## DESIGN STANDARDS BULLETIN

Appendix M – Building Signage

Date Issued: July 30, 2018

SIGN TYPE J  
BRaille EXIT SIGN

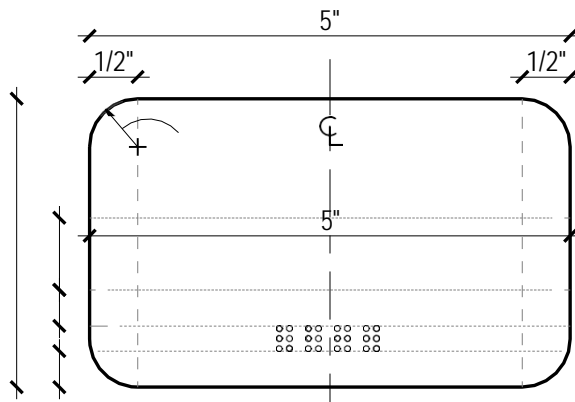
Signage in the exit stairwells, Sign Type K was incorrect per the current code.

Revise sign types J, K and K.1 per the attached.

WHITE NON-TACTILE CHARACTERS  
TREBUCHET MS  
ON BLUE BACKGROUND -  
TO MATCH COLOR PMS 540

REFER TO 2012 IBC 1011.4 RAISED CHARACTER AND BRaille EXIT SIGNS

BRaille SHALL BE CONTRACTED  
(GRADE 2) AND SHALL COMPLY WITH  
ADA 703.3 BRaille - TYPICAL
